October 4, 1977

NOTE TO: Karl R. Goller, Assistant Director for Operating Reactors, DOR  
FROM: A. Schwencer, Chief, Operating Reactors Branch #1, DOR  
SUBJECT: GETR REREVIEW - ABILITY TO COOL CORE ASSUMING COOLING  
WATER ABSENCE OF FULL SEISMIC DESIGN CAPABILITY

FIG. 3-1 Temperature rise of center fuel element vs. total reactor power for infinite running time. LTR-15-element core, 3 control rods.

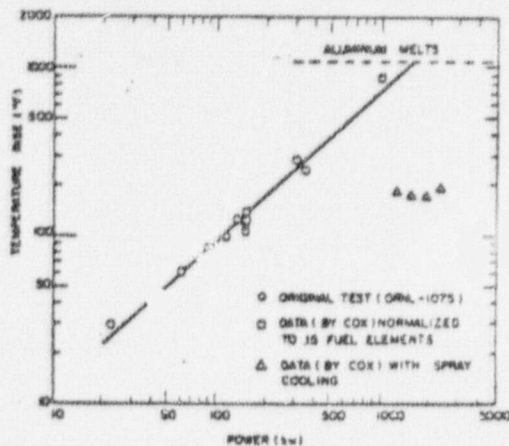
For comparison GETR, which has 21 MTR plate type fuel elements, operates at 50 MWt at full power while the T. J. Thompson article states that maximum power from 21 elements before melting would occur is about 2250 kw (or 2.25Mw). This threshold value is about 22 times lower than the GETR's 50 MW rating.

The observed points extrapolated to infinite running time for a 15-element core are plotted in Fig. 5-1 [82]. It is evident that the 15-element core should melt on loss of water after operating at power levels above about 1500 kw. With a 21-element core the maximum power before melting on loss of coolant would be about 2350 kw.
